TSI 01/11

Audi | Seat | Škoda | VW 1.9 litre Diesel Injection

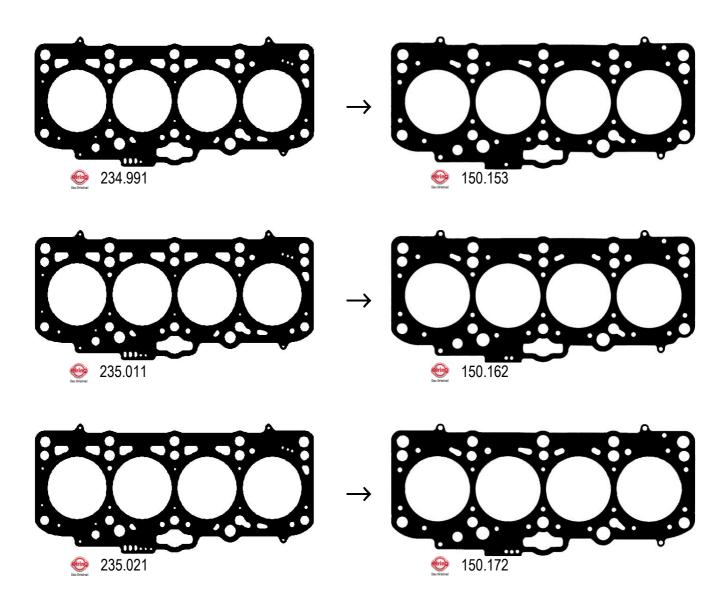
The modification of the water passageways improves the thermal efficiency rate.

The gaskets replace № 234.991 | 235.011 | 235.021 and can be fitted retroactively.
